JUNEAU STAKE CHAPEL

JUNEAU STAKE CHAPEL
ENGINEERS CUTOFF ACCESS - OPTION C
Juneau, Alaska 99801

PROJECT NARRATIVE (Revised 3/7/2012)

From: Epstein, David B (DOT) [david.epstein@alaska.gov]
Sent: Monday, March 12, 2012 11:34 AM
To: Nicole Jones
Cc: Good, Sheila D (DOT)
Subject: RE: LDS Church-revision. comments requested

ENGINEERS CUTOFF ACCESS - OPTION E

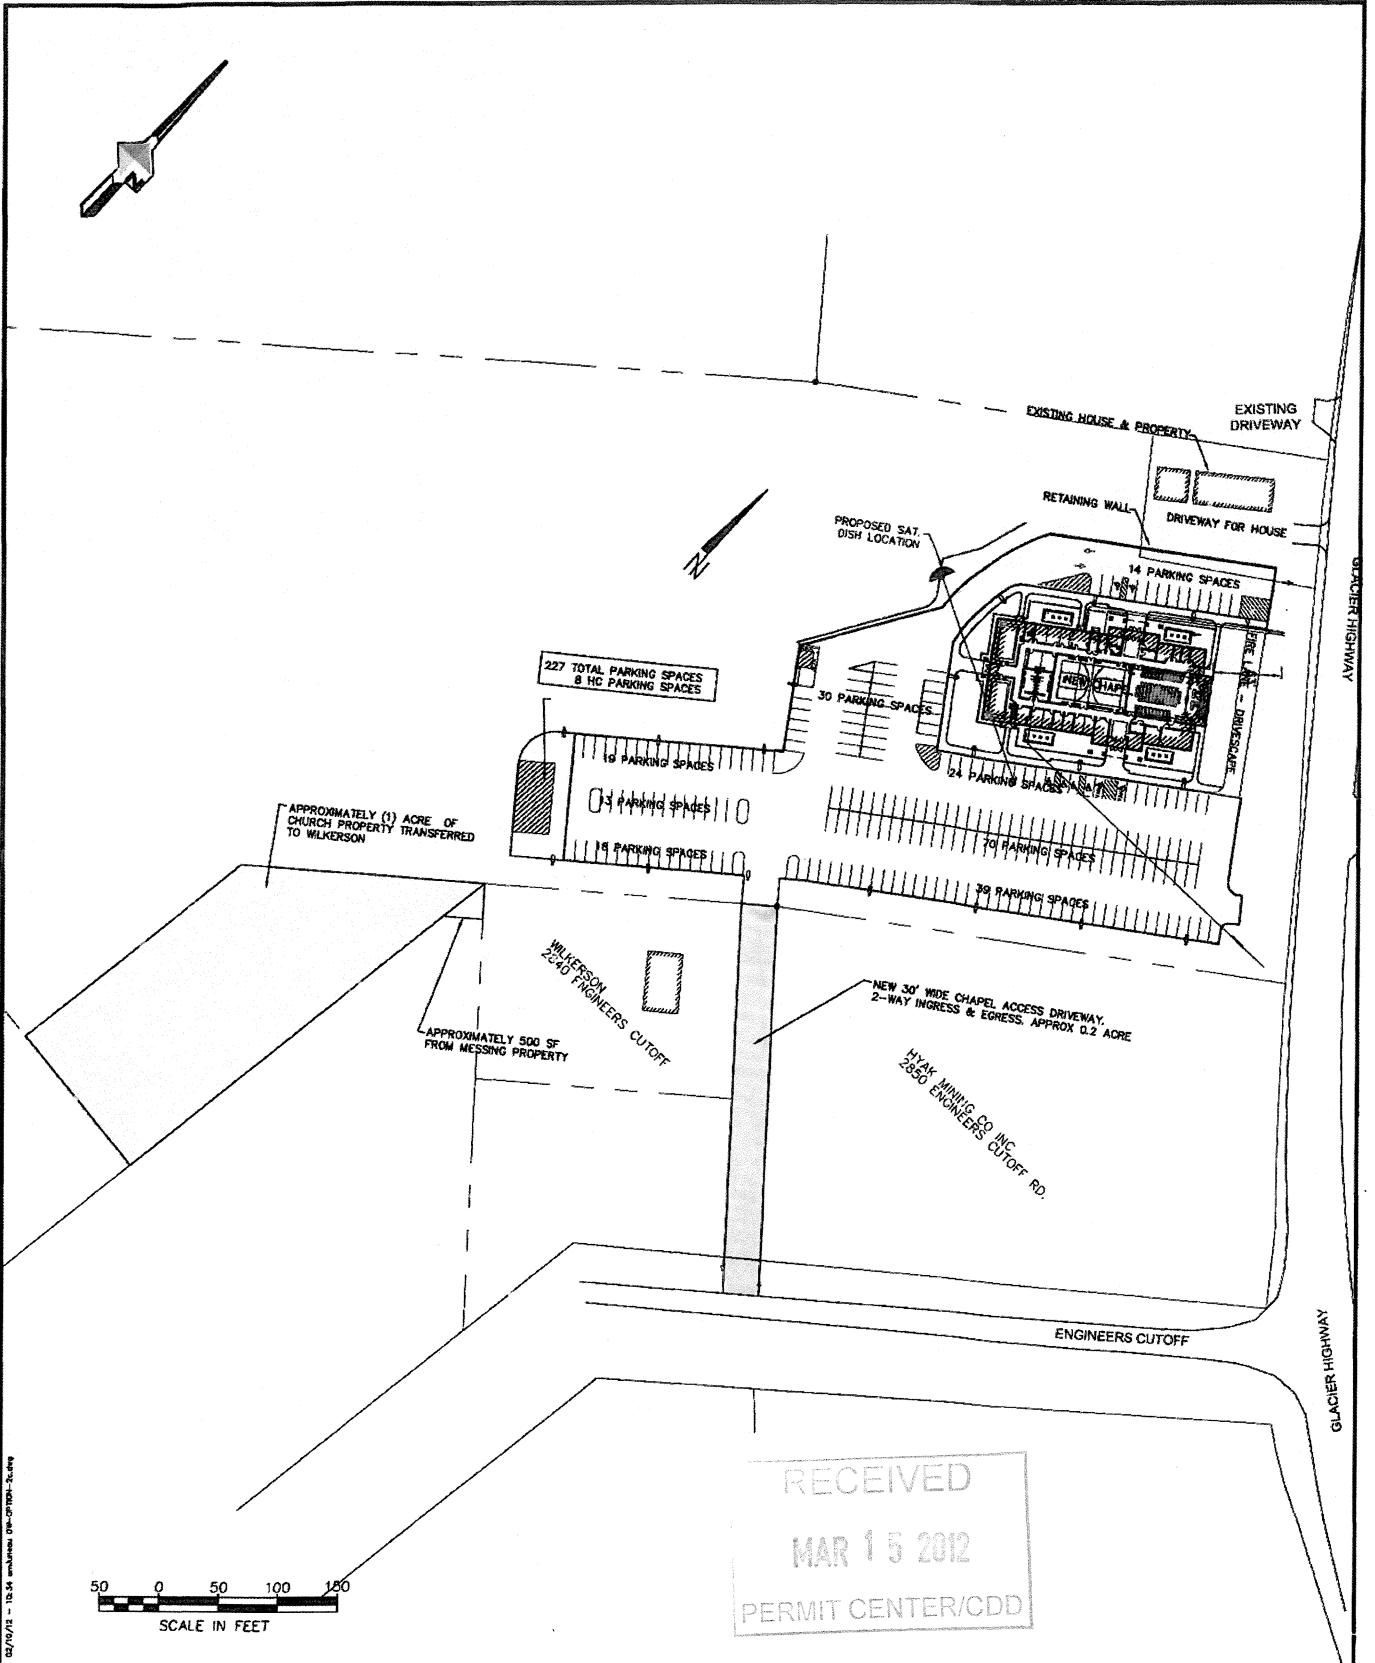
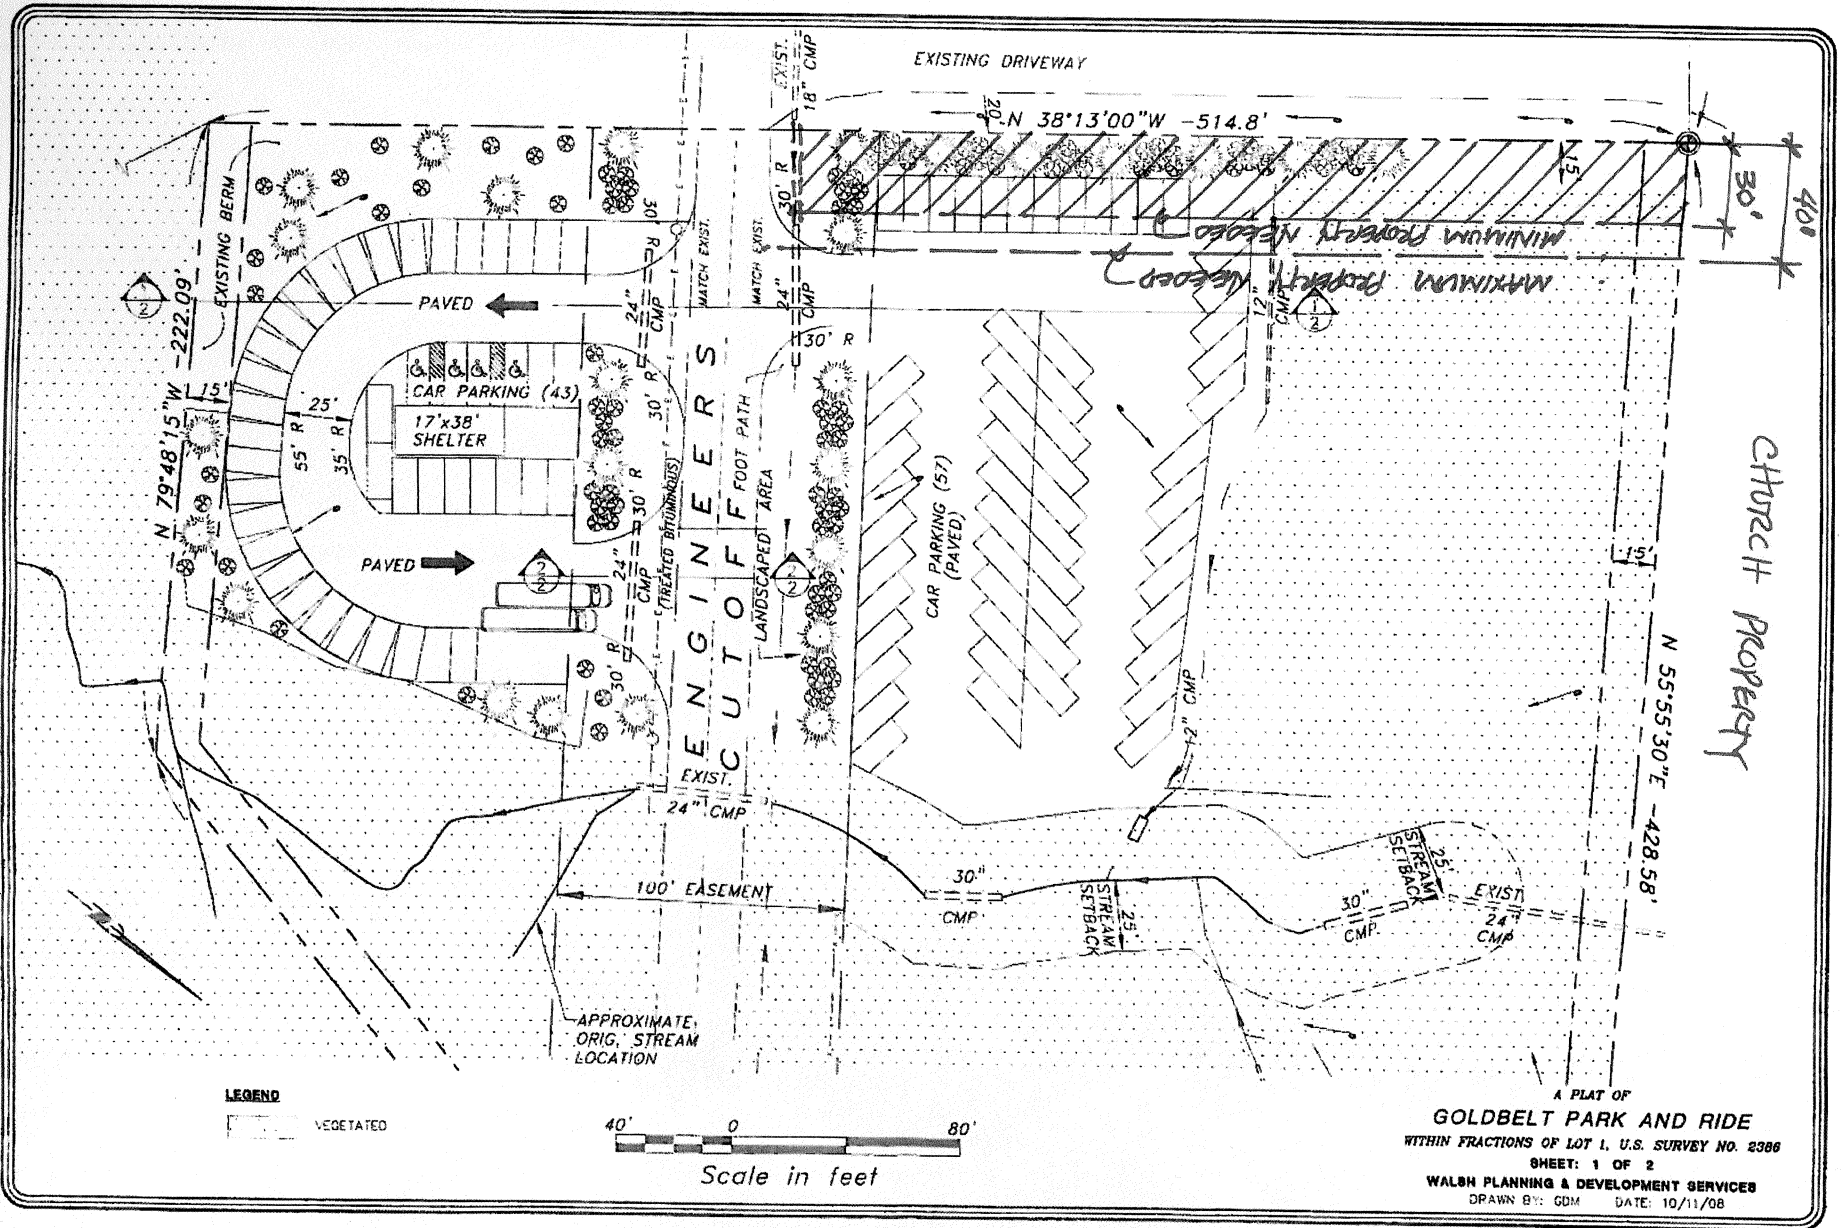
DOT&PF supports the second option that provides access via a driveway from Engineers Cutoff Road.

If negotiations to achieve this fail, then we will agree to the direct connection to Glacier Highway augmented with the mitigation of a center left-turn lane and necessary associated actions (e.g., roadway alignment modifications, utility relocation, drainage modifications, etc.).

Attached is an alternate plan for access to the LDS church site. Please review the new configuration. If at all possible, the earlier that you can provide comments the better.

Sheet Title:
OVERALL SITE PLAN

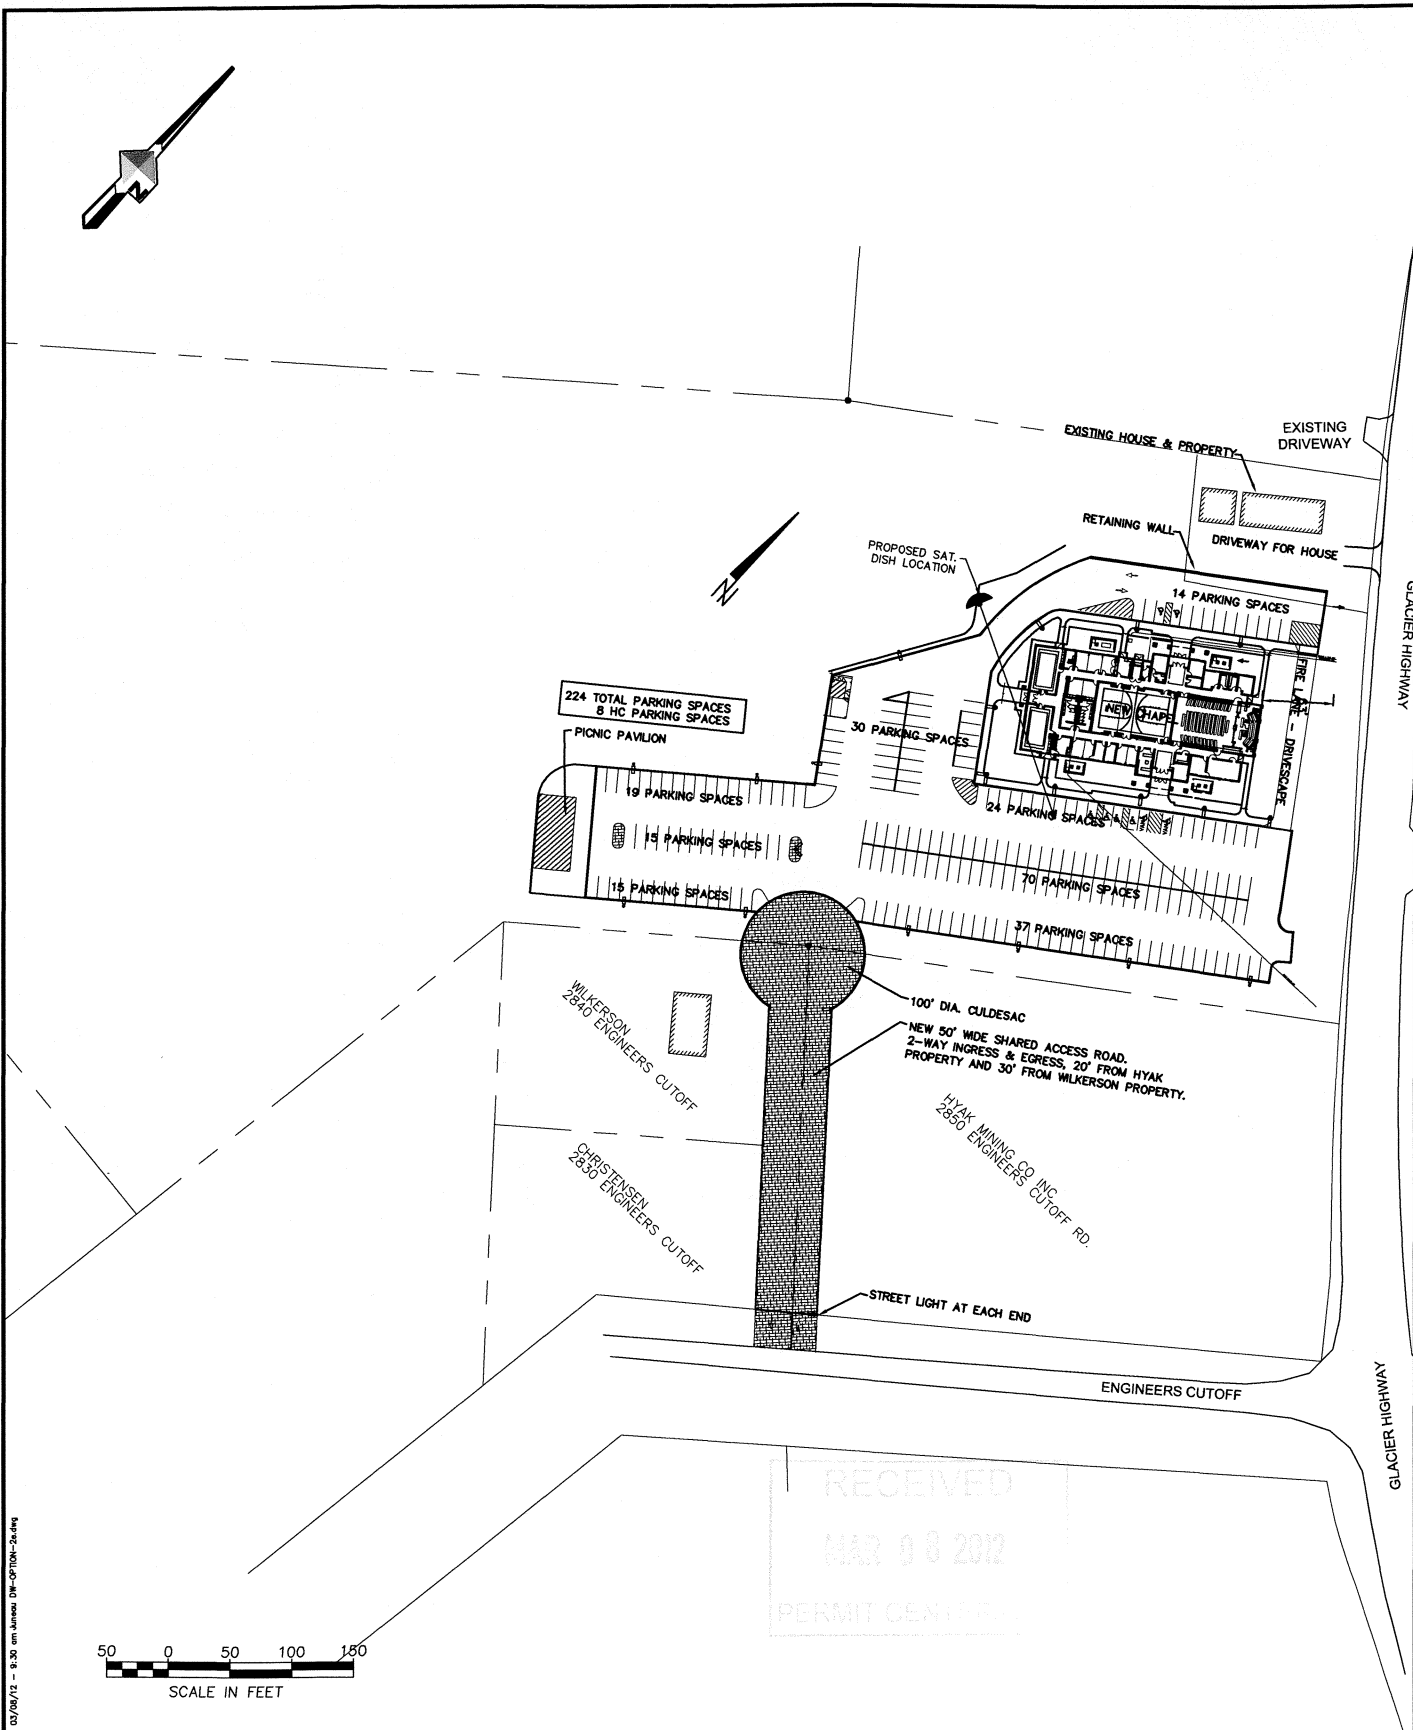
Two options are being presented to attempt to satisfy the Alaska Department of Transportation's request for an alternate route to Glacier Highway. The primary option One is illustrated on Site Plan C2.0 with a single driveway from the Church property onto Glacier Highway set opposite Hamilton Drive. The second option for site access would be from Engineers Cutoff via a new dedicated road, built to CBJ Standards, taken from two neighboring properties. (Appendix 3 – Option 2E).

Following discussions with the DOT, the Building has been shifted to the north from the original application, reducing the parking on the north side to one single row with 14 parking spaces. This has allowed the meeting house entry drive (Option 1) to be aligned with Hamilton Street across the highway. This will provide access directly into the parking lot, reduce cross traffic conflicts reduce stacking in the center lane. A turf block type of emergency access drive is included across the frontage to allow emergency vehicles full access around the building.
